**Request for Additional Information No. 547, Supplement 3**

**U. S. EPR Standard Design Certification**

**SRP Section: 03.07.02 - Seismic System Analysis**

**Question 03.07.02-76:****Open Item****Follow-up RAI 371, Question 03-07-02-67 (Supplement 24 Response)**

**Figure 3.7.2-50—Static FEM vs. Dynamic FEM Spectrum Comparison at Elev. +63 ft, 11-3/4 in (+19.50m) - Reactor Building Internal Structure, 5% Damping, X-Direction**

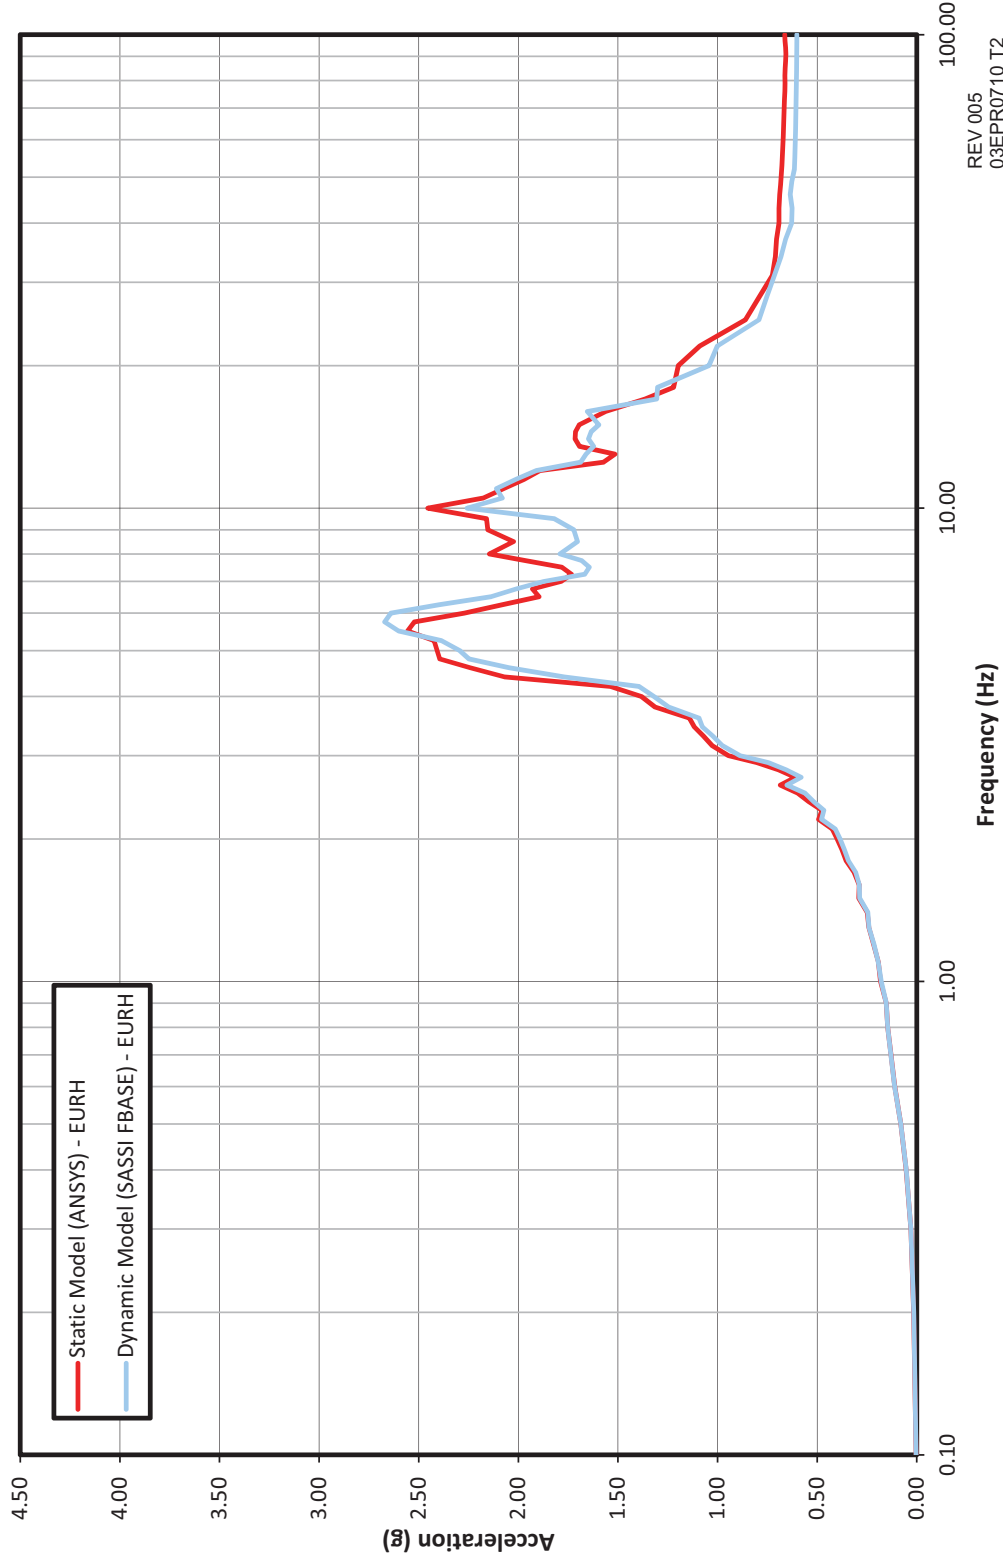
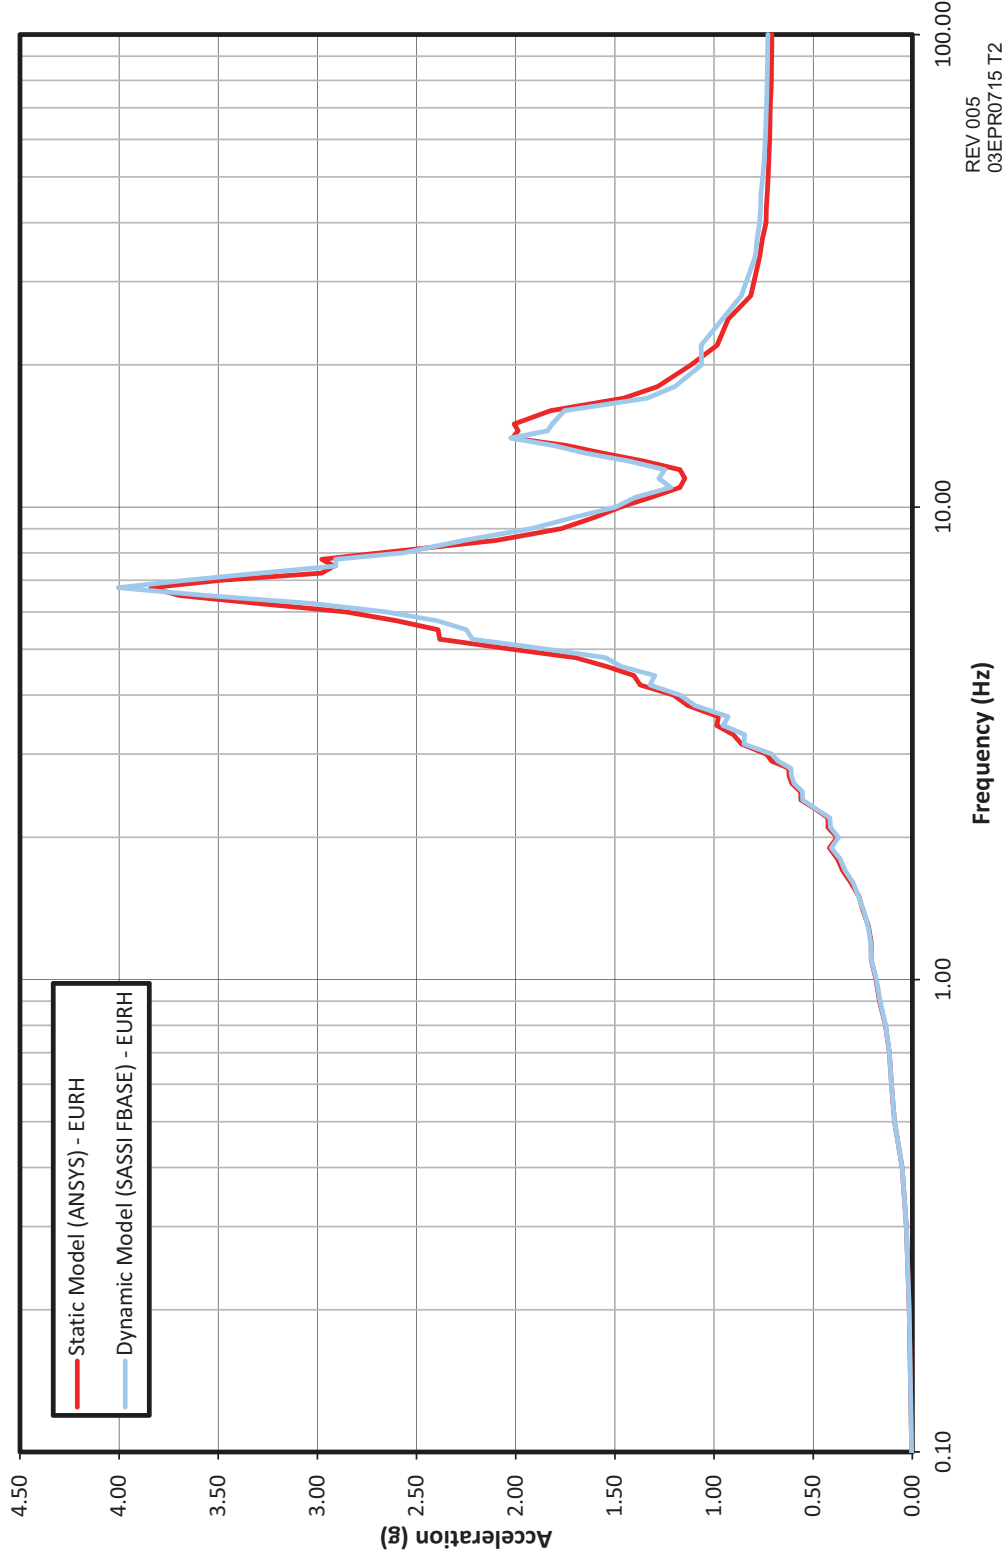
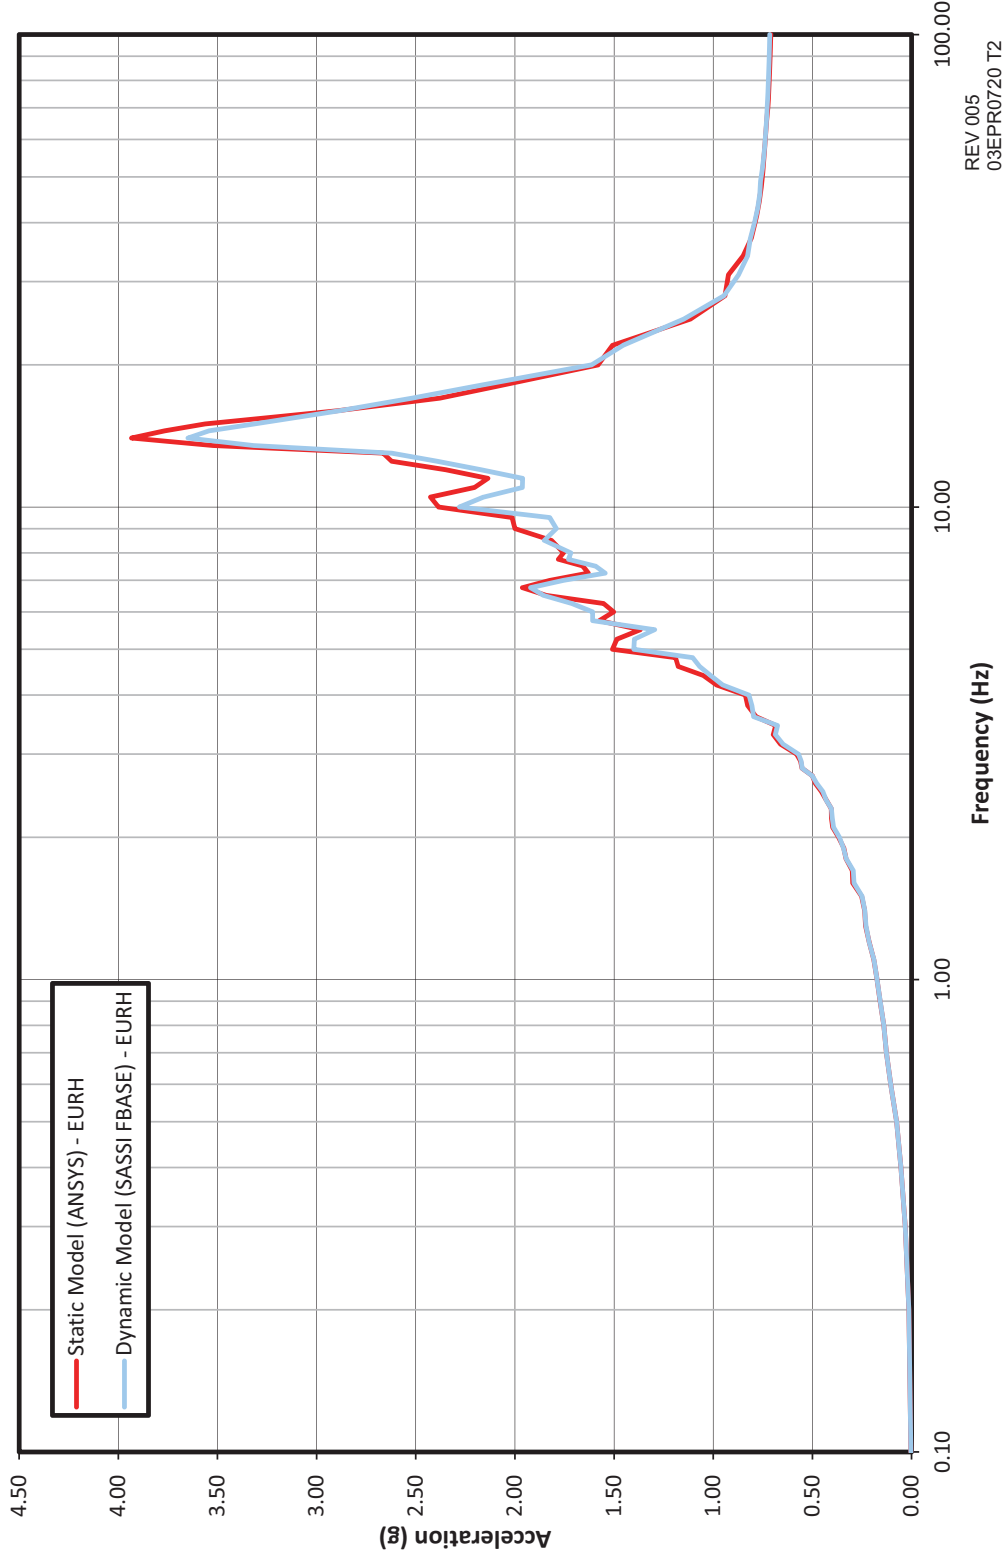
2. A comparison of ISRS for the Reactor Building Internal Structure (RBIS) at elevation 63 feet, 11  $\frac{3}{4}$  inches for the Z or vertical direction (Figure 03.07.02-67-36) shows the static model result at a frequency of about 15 Hz to be 31 percent higher than the dynamic model result. In addition, at 15 Hz both results exceed the ISRS envelope shown on FSAR Figure 3.7.2-79 (Revision 3). At this same elevation a similar result is observed for the X direction (Figure 03.07.02-67-34) where the static model result at a frequency of about 10 Hz is 44 percent higher than the dynamic model result. At 10 Hz, both results exceed the ISRS envelope shown on FSAR Figure 3.7.2-79 (Revision 3). The ZPA for the static model in the X direction is 20 percent higher than that of the dynamic model. Since the ISRS envelope includes soil case 5ae which has a shear wave velocity of 13,123 ft/sec and in effect provides a rigid support for the NI, it is not clear why the fixed base SASSI result exceeds the results for case 5ae.

The ISRS for the RBIS at elevation 63 feet, 11  $\frac{3}{4}$  inches are presented in updated FSAR figures 3.7.2-50 through 3.7.2-52 in the attached mark-up. Given the modeling differences which inherently exist between the static and dynamic models, the slight differences remaining in the ISRS comparisons are acceptable and dynamic compatibility has been achieved for the RBIS.

With regard to the FSAR ISRS exceedances by the dynamic and static models at elevation 63 feet, 11  $\frac{3}{4}$  inches, it should be noted that the ISRS nodal locations used for evaluating compatibility differed from those used in the FSAR ISRS. Consequently, the comparisons between the FSAR ISRS and the static/dynamic compatibility curves were not like-for-like and differences can be expected. Likewise, the comparisons between the fixed base case

**Figure 3.7.2-53—Static FEM vs. Dynamic FEM Spectrum Comparison at Elev. +16 ft, 10-3/4 in (+5.15m) - Reactor Building Internal Structure, 5% Damping, X-Direction**

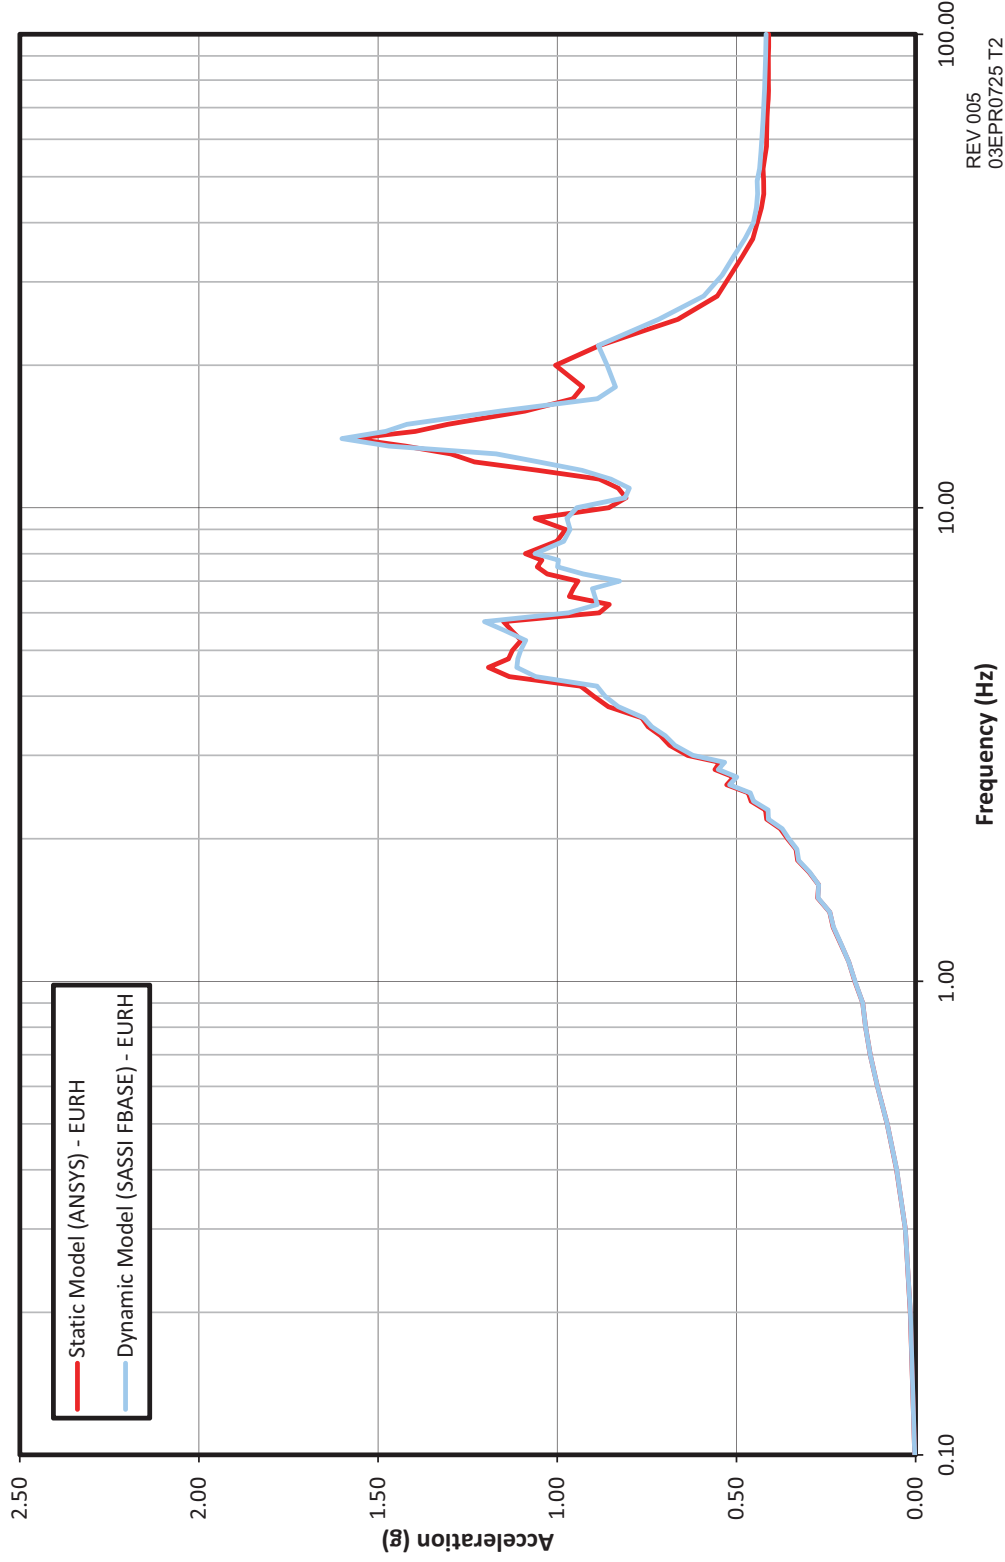
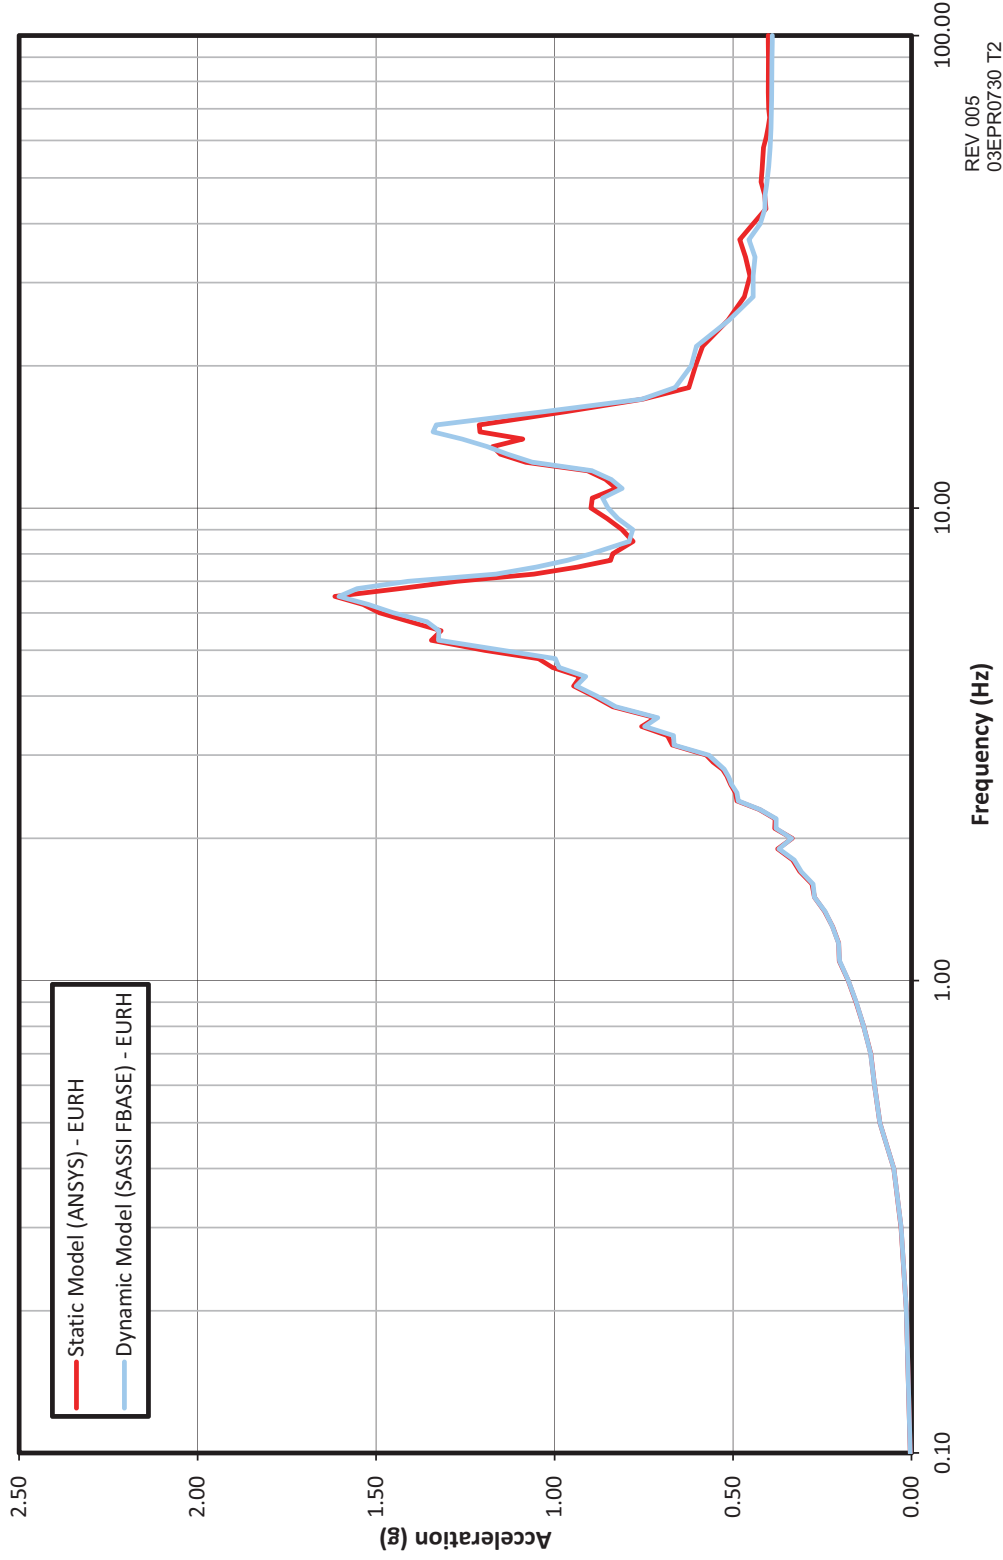
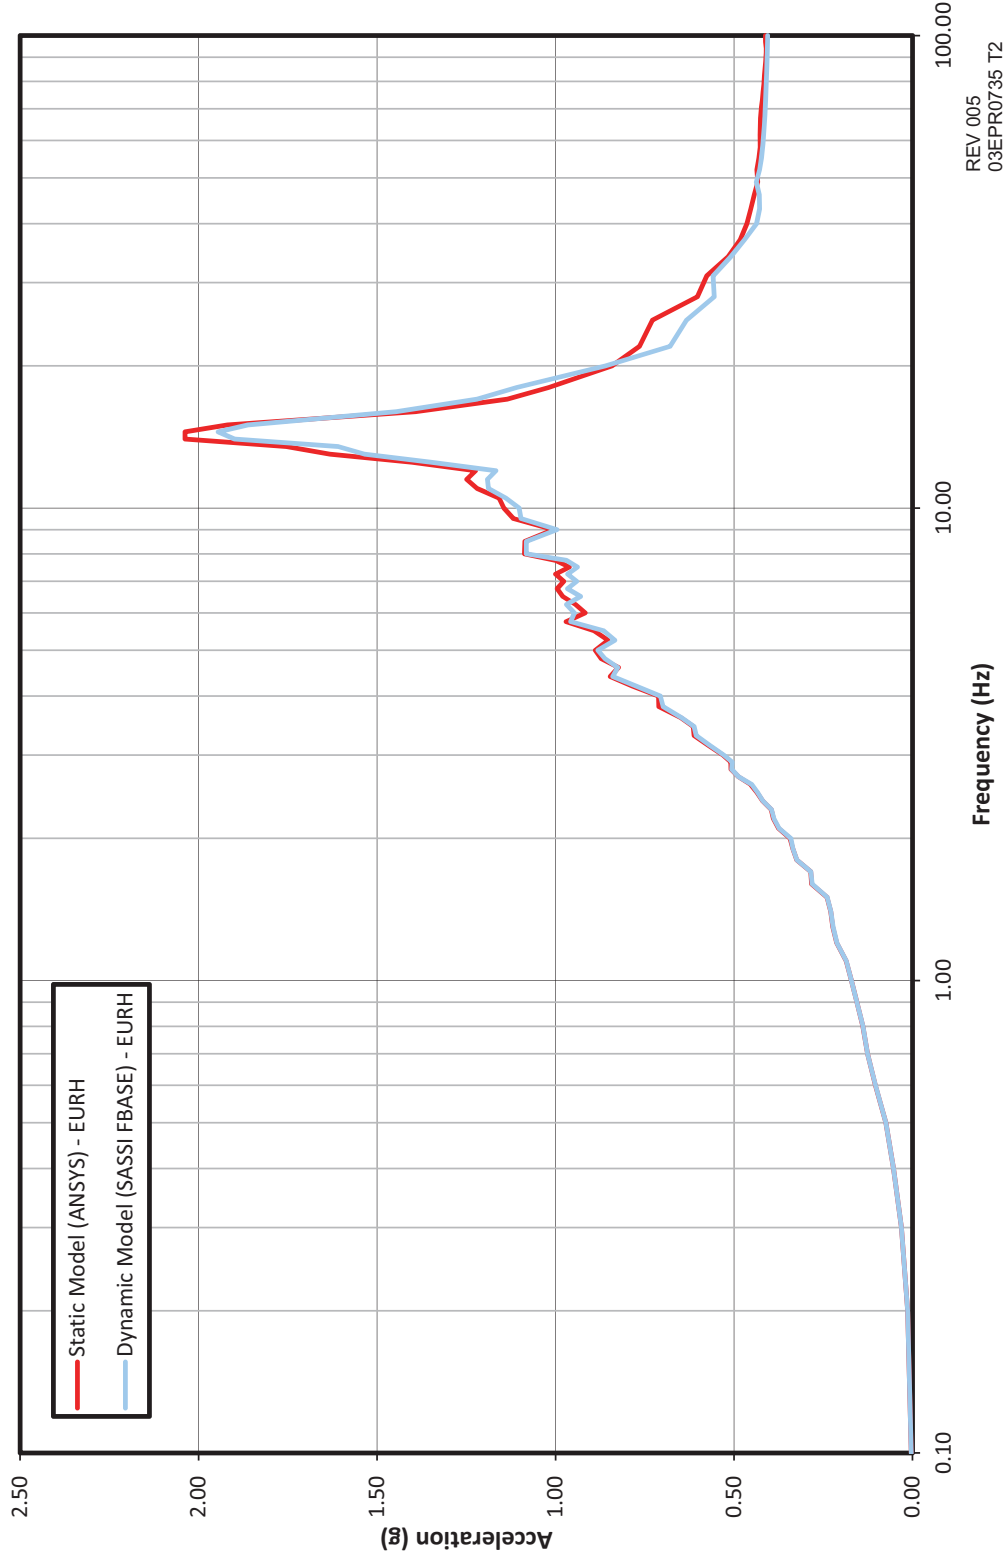
3. A comparison of ISRS for the RBIS at elevation 16 feet, 10  $\frac{3}{4}$  inches for the Y direction (Figure 03.07.02-67-38) shows the static model result at about 15 Hz is 24 percent higher than the dynamic model result. At 15 Hz, both results exceed the ISRS shown on FSAR Figure 3.7.2-75 (Revision 3). For the Z direction at about the same frequency the static model result exceeds the dynamic model result by about 14 percent.

3. As described in Item (2), new ISRS for the RBIS at elevation 16 feet, 10  $\frac{3}{4}$  inches for the Y direction (RAI 371 Figure 03.07.02-67-38) have been generated and the comparisons are now more favorable. See updated FSAR figures 3.7.2-53 through 3.7.2-55 in the attached mark-up. Additionally, the comparisons between the FSAR ISRS and the static/dynamic compatibility curves were not like-for-like and differences can be expected, thus explaining any FSAR ISRS exceedances.
